# CITY OF PORTLAND, MAINE

## HISTORIC PRESERVATION BOARD

#### HISTORIC PRESERVATION BOARD MEETING

**TO:** Chair Pollard and Members of the Historic Preservation Board  
**FROM:** Rob Wiener, Preservation Compliance Coordinator  
**DATE:** October 2, 2020  
**RE:** October 7, 2020 **Public Hearing** – Exterior Alterations, Wharf Street Level

1 Wharf Street Exterior Elevation – Existing  
SCALE = 1/4" = 1' - 0"

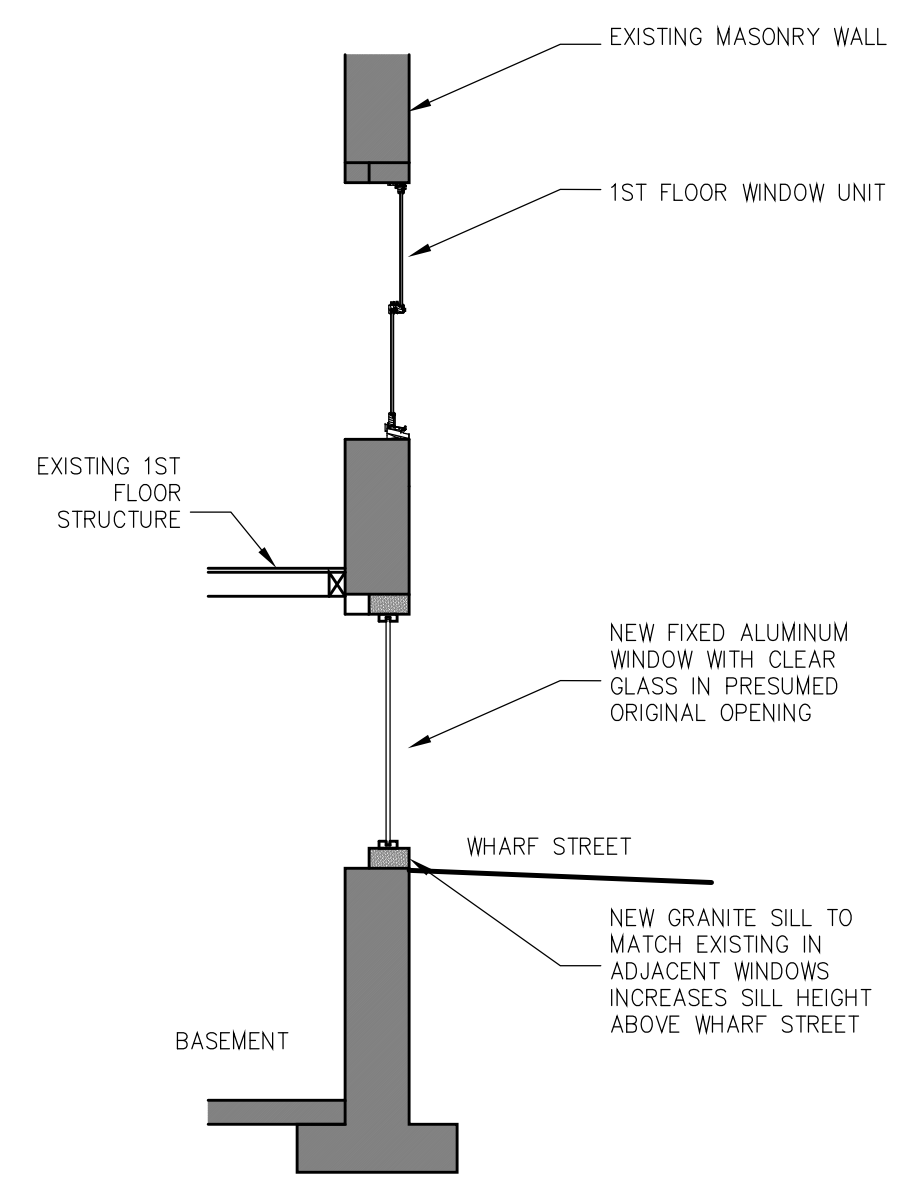
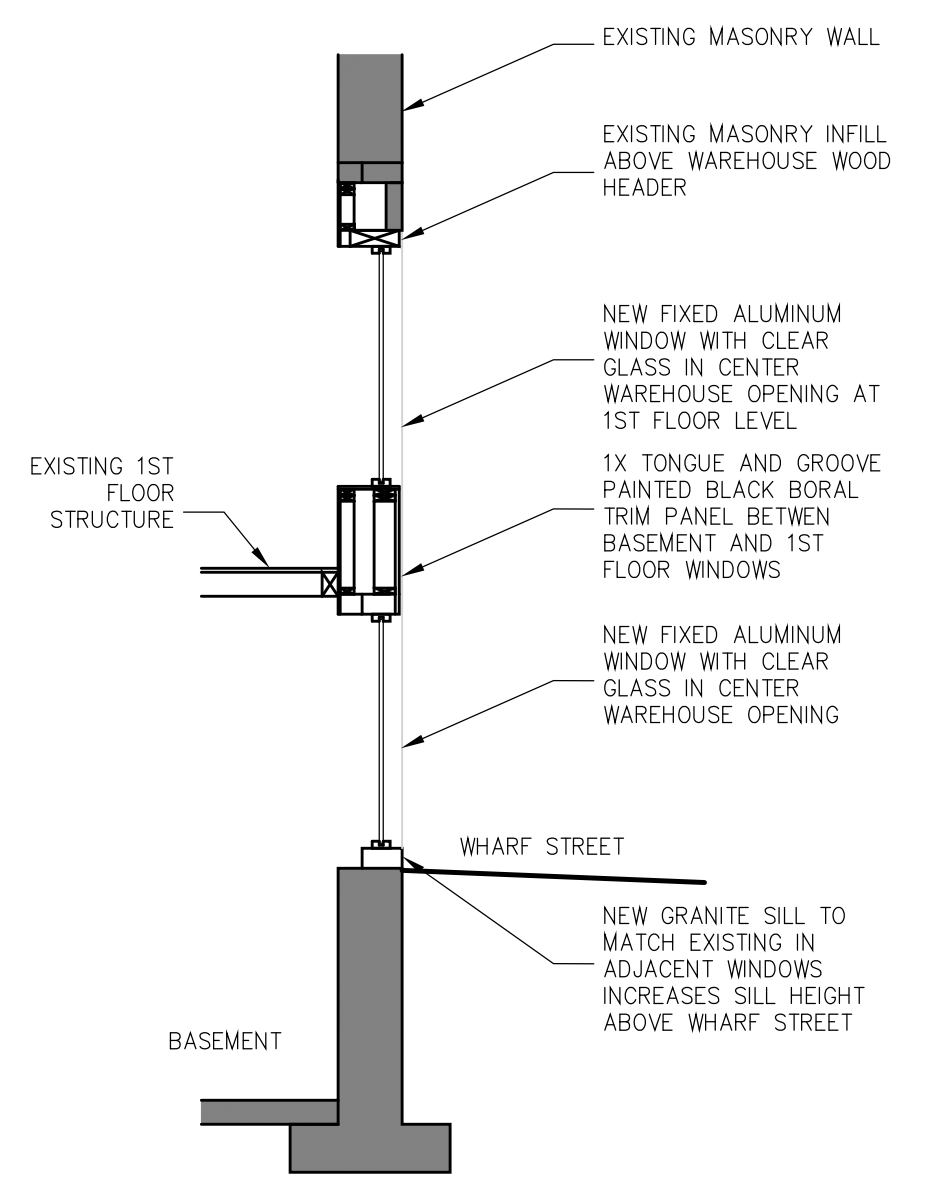
- The size and almost square proportions of the two center windows lead staff to prefer the alternative with a center division and more vertically oriented proportions that are more similar to the patterns in the building. Narrower windows there will still be construed as modern interventions, and as Board members will have noticed, a variety of approaches have been used on other Wharf Street facades – some more successful than others.

- On paper one notices the strong vertical line going all the way up through the center of the tall opening; continued as it is by the diagonal board panel, it may slightly overemphasize the vertical division but the Board can decide if it is the better alternative or if another solution can be found.

- Staff questions the number of lights proposed. Two over the door and sign board have a clear utility. Further lighting of Wharf Street and Union Street with the other four fixtures seems possibly excessive and possibly a matter the City should address. Other owners and tenants on Wharf Street have expressed concerns for pedestrian and patron safety, and the need to illuminate outdoor seating. Staff suggests perhaps outdoor dining can be illuminated by other means than wall-mounted fixtures, and in the long run hopes a coordinated approach might be developed for Wharf Street.

- A wider double door system of wood with full glass is now aligned under the windows above.
- Two large, single light windows signaling their contemporary origin occupy the center of the façade, with the panel between them recalling the diagonal boarding of the freight opening, and the original brick still visible above.
- After surveying Wharf Street buildings again, Mr. Keeler still prefers to see the two large center windows as single light units. (See Sheet A2.3) As an alternative he has provided Sheet A2.4, showing each opening as two narrower units.
- The Wharf Street window to left is narrower, and aligned below the existing stone header.

Canopy Detail : 1 1/2 in = 1 ft

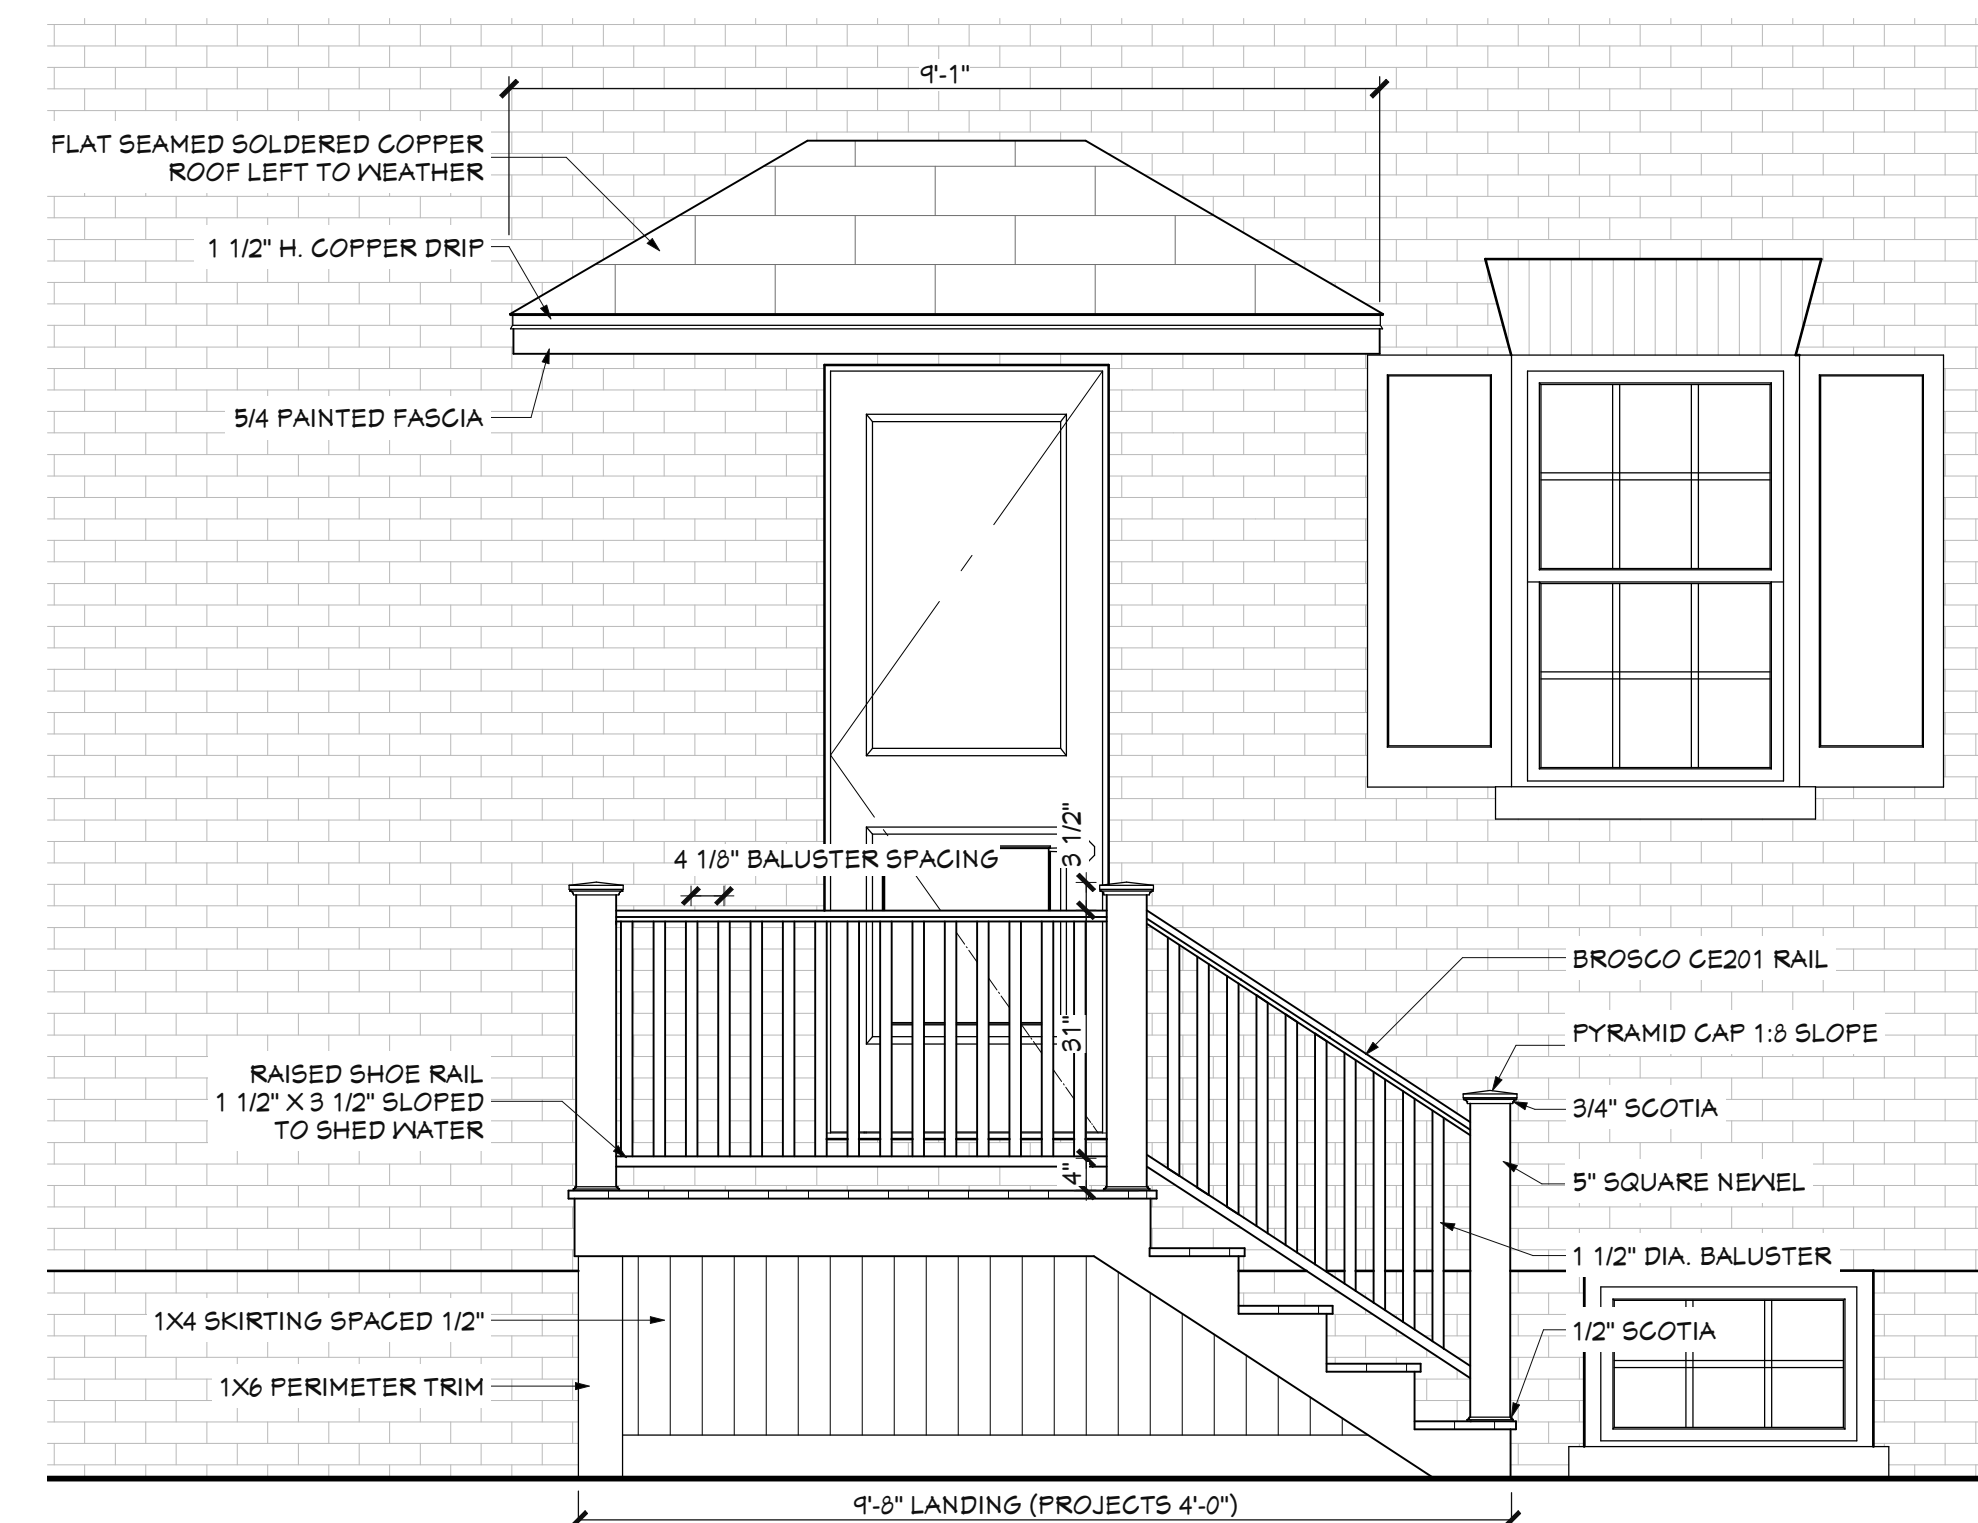
In the 8/19 staff report, staff questioned the rationale for pursuing the proposed design solution for the new entry and canopy, given the fact that the entry's relationship to the rear addition would not be evident as viewed from Spring Street and the rather striking design department for such a small entry addition seemed rather forced. During Board discussion, most Board members echoed this observation and encouraged a more straightforward design solution that was drawn from the general design vocabulary of the historic structure. Board members also questioned the canopy's shed roof form. Board members did not object to the splayed nature of the stairs.

- We have re-designed the proposed east entry.
  - The stairs have been reversed to face the sidewalk. The Druce's plan to change the way they use the existing garage. The door to the front will become their primary means of passage to the garage. This orientation is also more welcoming to informal visitors likely to use this secondary entrance. The geometry of the stair and canopy has been simplified to a simple rectangular footprint. The splayed shape of the stair has been eliminated.

- Staff suggested we consider reducing the size of the roof to cover only the landing and not the stairs. We reviewed this option but ultimately decided we would prefer that the roof provide a better shelter for the Druce's use of the stairs and door in poor weather. This will be their primary means to access the house.

- The finishes of the landing have been revised to eliminate the Richlite panel. We now propose spaced 1x4 vertical board skirting running from a 1x6 trim board below the decking down to grade. We now propose a painted wood railing with 1 1/2" diameter balusters. The round balusters are intended to reference the strength of the much larger turned balusters at the west entry but employ a scale appropriate to this secondary entrance. Turned balusters were explored but appeared too delicate in this context. The newels will be simple square posts with a pyramid cap supported by a Bed molding and set above the height of the handrail. This detail also references the newel and cap at the west entrance albeit at a reduced proportion. The raised bottom rail will be a square profile subtly sloped to shed water.
